Proposed Change 2030

Code Reference(s):	NBC20 Div.B 9.31.2.3. (first printing)
Subject:	Accessibility, Visitability and Adaptability of Dwelling Units
Title:	Reinforcing Stud Walls in Washrooms for the Future Installation of Grab Bars: Structural Strength
Description:	This proposed change introduces performance-based requirements and prescriptive pathways for material selection when reinforcing stud walls of washrooms in dwelling units for the future installation of grab bars.
Related Proposed Change(s):	PCF 1882, PCF 1884, PCF 1958, PCF 2031

Figure [A-9.31.2.3.(3)(a)]
Multiple pieces of lumber used as reinforcement

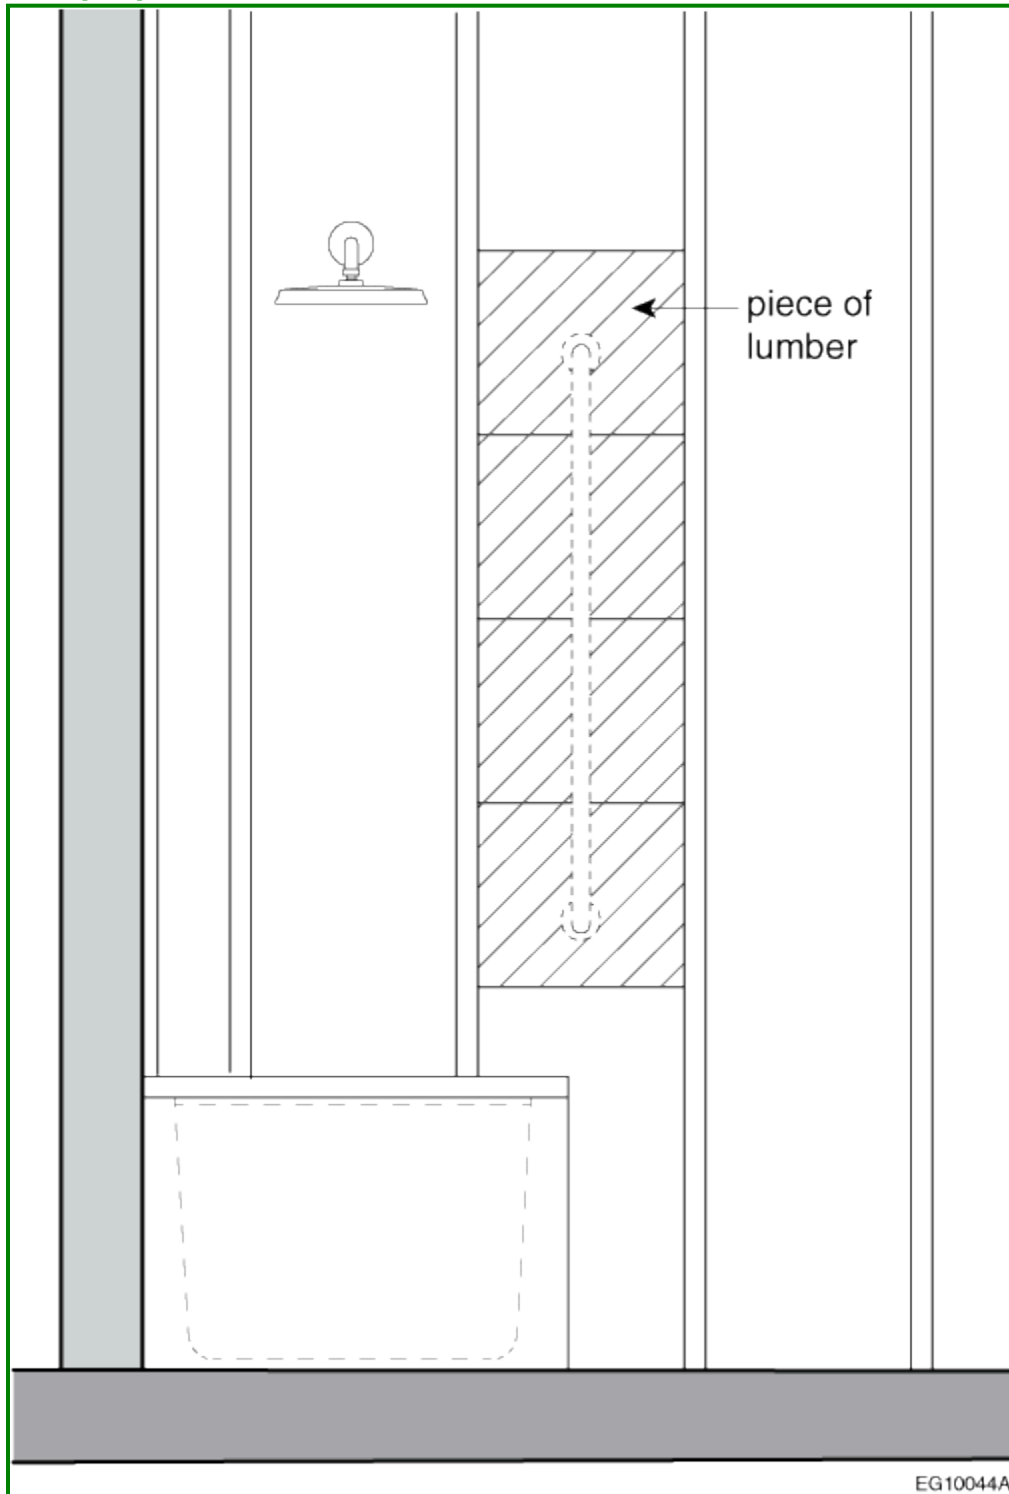
Note A-9.31.2.3.(3)(a) Lumber Reinforcement.

Multiple pieces of lumber may be used as reinforcement to achieve the desired wall coverage, as illustrated in Figure A-9.31.2.3.(3)(a).

[a] --) solid lumber having a minimum thickness of 38 mm (see Note A-9.31.2.3.(3)(a)), and

Figure [A-9.31.2.3.(6)]

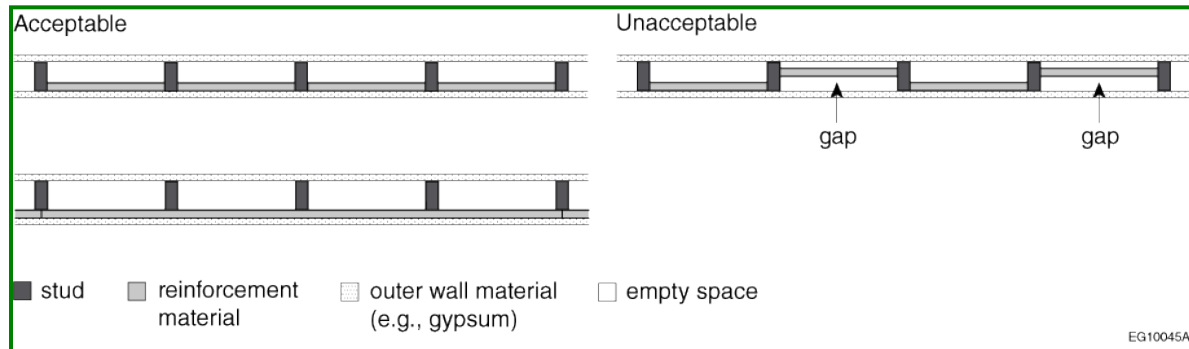
Since the structural strength calculations that support Article 9.31.2.3. assume that the reinforcement material is in full contact with the outer wall material (e.g., gypsum) that it is installed behind, gaps between these materials are not permitted. Figure A-9.31.2.3.(6) illustrates examples of wall assemblies with acceptable and unacceptable configurations of the reinforcement material with respect to the outer wall material. In

the unacceptable configuration, there are gaps between some of the pieces of reinforcement material and the outer wall material that they are installed behind.

- [6] --)** Where the reinforcement material is installed behind other materials, gaps are not permitted between the reinforcement and the outer materials. (See Note A-9.31.2.3.(6).)
